Serial: NPD-NRC-2008-031  
September 12, 2008

**Subject: Levy Nuclear Plant Units 1 and 2 (LNP)  
NRC Project Number 756  
LNP COLA Supplemental Information**

Primary and Orthogonal Fracture Pattern  
 Local Avon Park Formation Outcrops  
 Figure 2.5.4.1-202

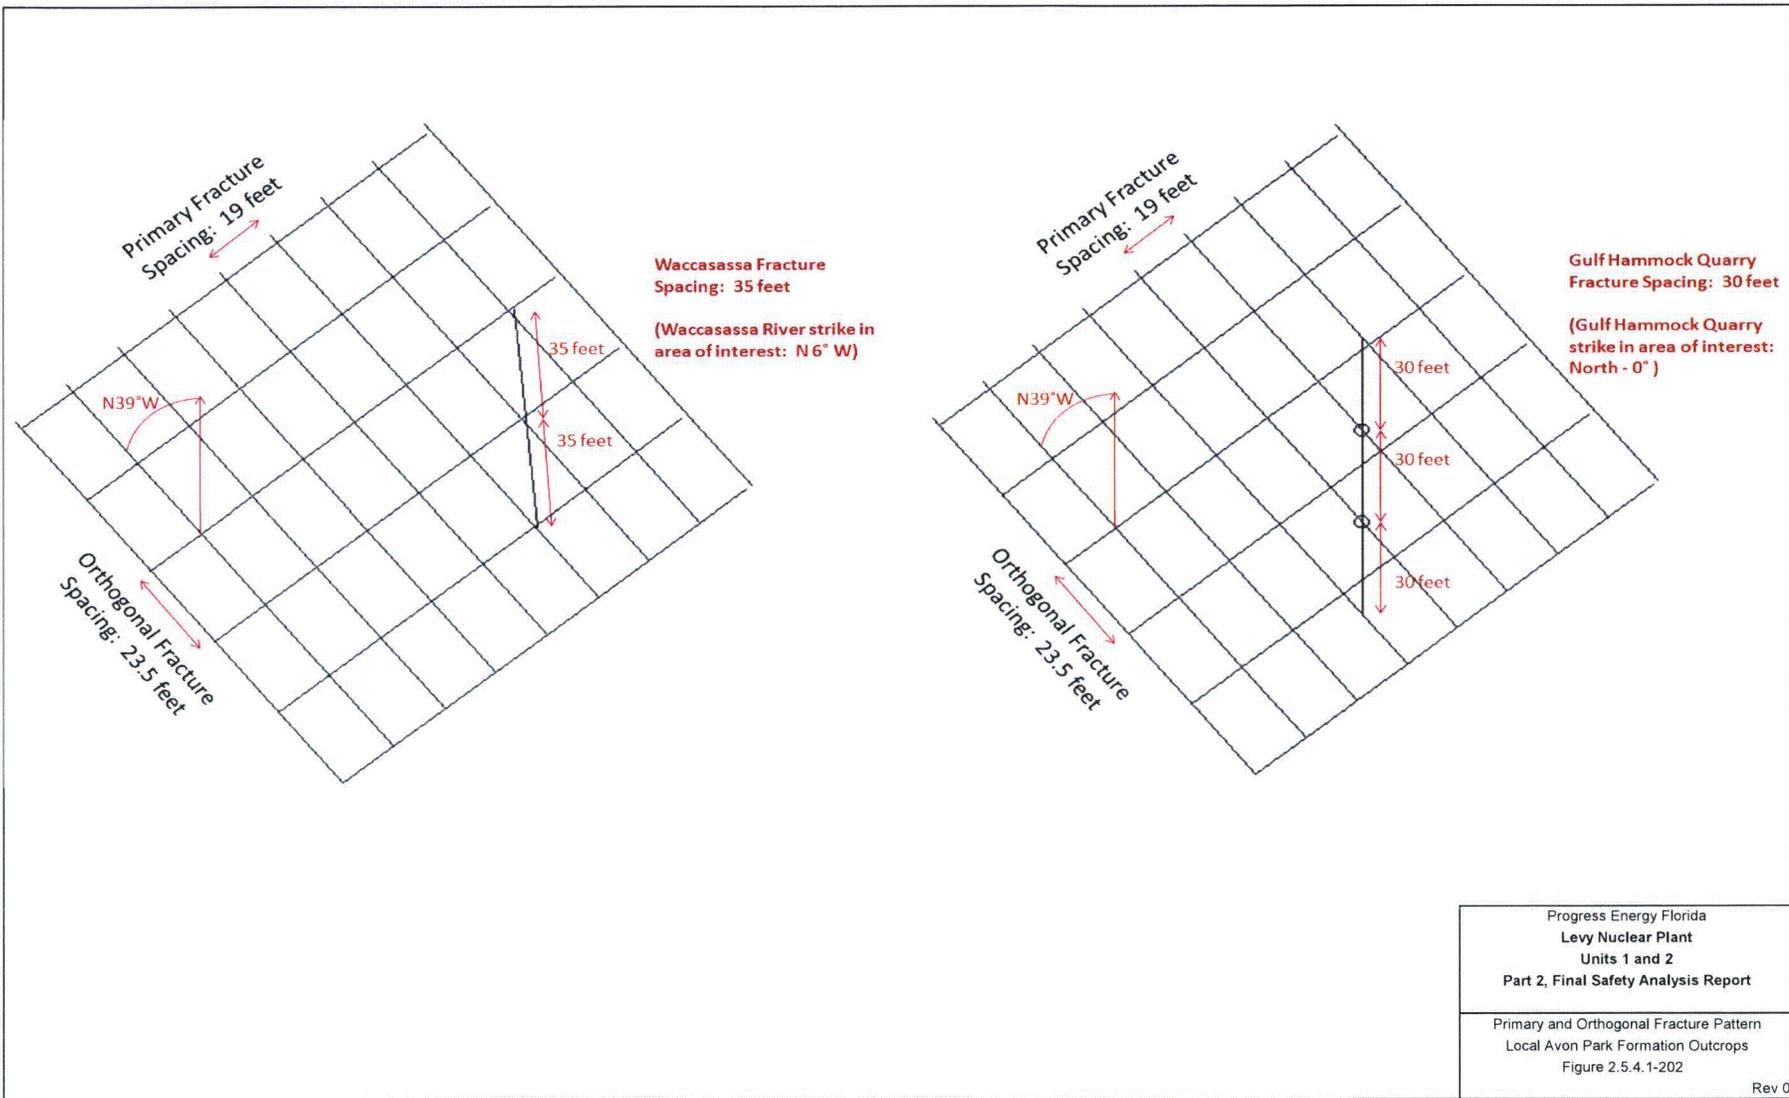
The Avon Park Formation outcrop strikes and the postulated fracture pattern associated with each are shown on Figure 2.5.4.1-202.

RCC Elastic Stress Analysis  
Example Cases for Cavity Placement  
Figure 2.5.4.5-204

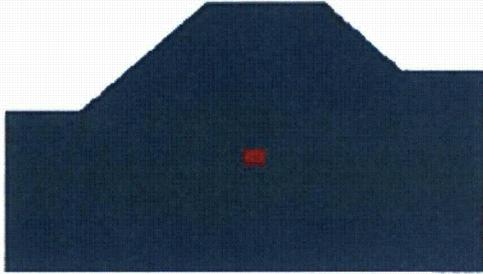
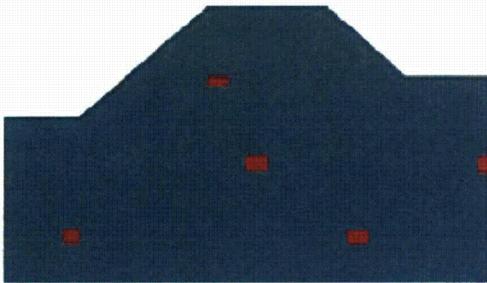
Examples of the locations of these cavities are shown on Figure 2.5.4.5-204.
